MEMORANDUM

Case # 11-15

**SUBJECT:** Modifications to Detail 210: Residential Speed Hump

**RESIDENTIAL SPEED HUMP**

Section 3B.25 Speed Hump Markings  
**Standard:**

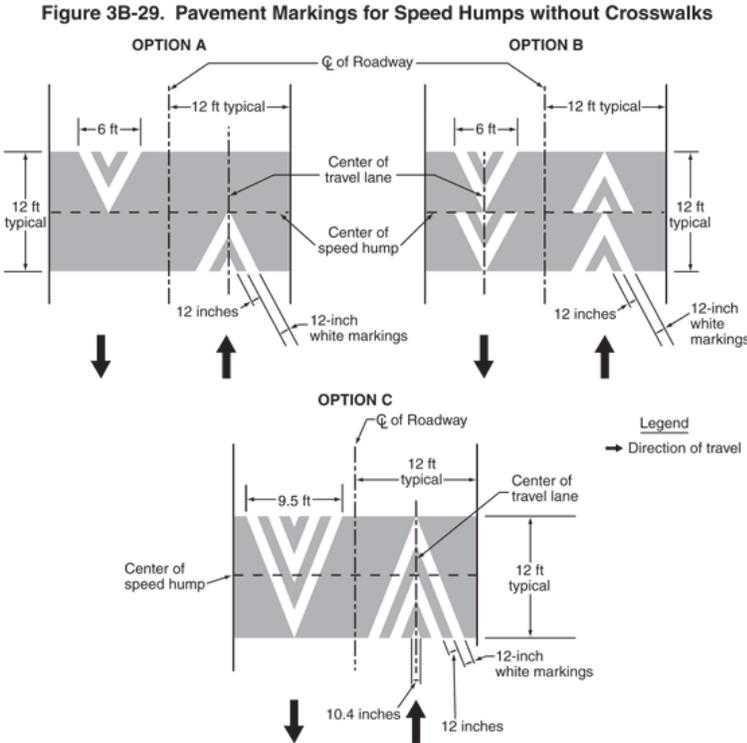
The current MAG Detail 210, Residential Speed Hump has become non-compliant with MUTCD marking requirements (see below). The point of the each chevron marking should face toward oncoming traffic.

01 If speed hump markings are used, they shall be a series of white markings placed on a speed hump to identify its location. If markings are used for a speed hump that does not also function as a crosswalk or speed table, the markings shall comply with Option A, B, or C shown in [Figure 3B-29](#). If markings are used for a speed hump that also functions as a crosswalk or speed table, the markings shall comply with Option A or B shown in [Figure 3B-30](#).

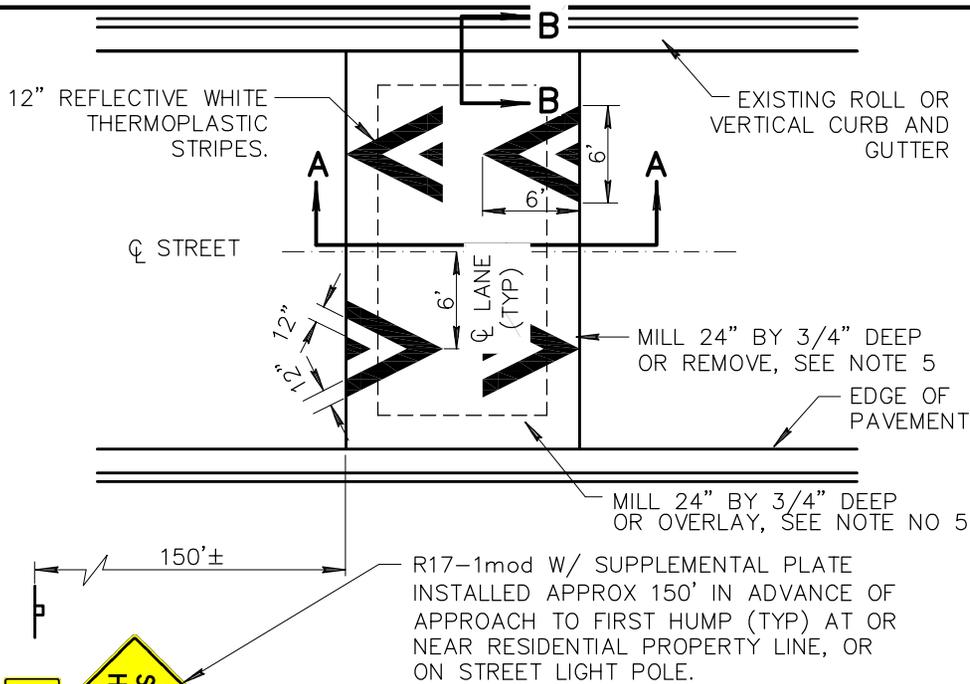
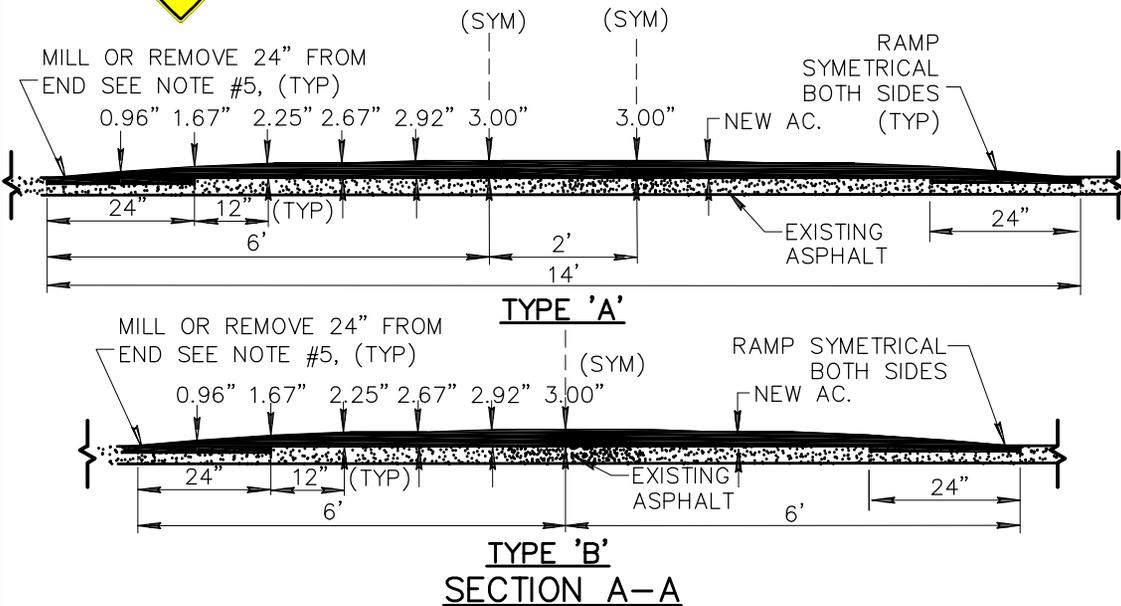
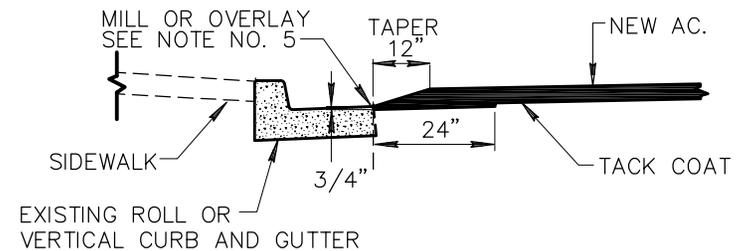
- Markings in accordance with MUTCD Figure 3B-29, Option B.
- Calling out 12" thermoplastic markings.
- Calling out the use of 1/2" asphalt mix.
- Clarifying the mill surface in the section views.
- Consolidating the profile requirements into one note.
- Creating two types: Type 'A' - 14' and Type 'B' - 12'.
- Specifying advance signing for the hump series.
- Locating the chevrons close to centerline to avoid obscuration by parked cars.

Also, we'd like to note that the alternate installation longitudinal joint method consisting of tapering the AC profile may be problematic to achieve.
